## SAF Achsen mit Haldex Scheibenbremse, Scheiben $\varnothing$ 430mm SAF Axles with Haldex Disc Brakes, Disc $\varnothing$ 430mm

### Sichtbare Merkmale der unterschiedlichen Bremsausführungen Visible features of the both brake types

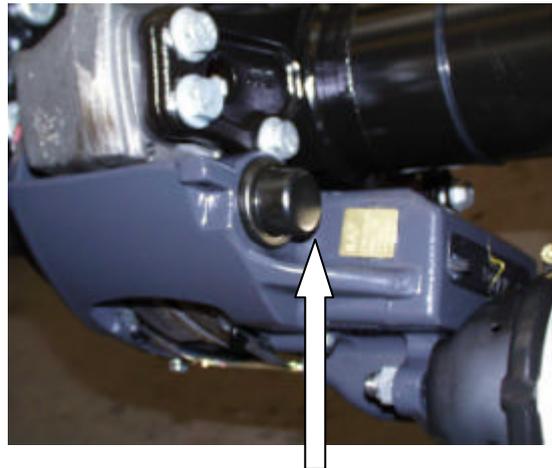
Im Zuge der Produktpflege wurde die Haldex Scheibenbremse überarbeitet.  
Die Bremsenkennwerte sowie die TDB Nummern bleiben unverändert.

**Bremse „alt“ mit Faltenbalg**  
„old“ brake with rubber boot

**Bremse „neu“ mit Stahlkappe**  
„new brake with steel cap

Due to improvements in the product, the Haldex disc brake was redesigned.  
The brake code and TDB-No. remain the same.

Es erfolgt keine Änderung der Achs- und Aggregatsachnummern. Im Ersatzbedarf kann die neue Bremse für die alte Ausführung verwendet werden. Es wird empfohlen, bei Austausch beide Bremsen einer Achse zu wechseln. Innerhalb eines Aggregates können Achsen mit der alten und der neuen Bremse montiert werden.

Axle and suspension numbers remain the same. The new brake can replace the old specification in spares. It is recommended when replacing, both brakes should be changed on one axle. Old and new brakes can be used within one suspension.
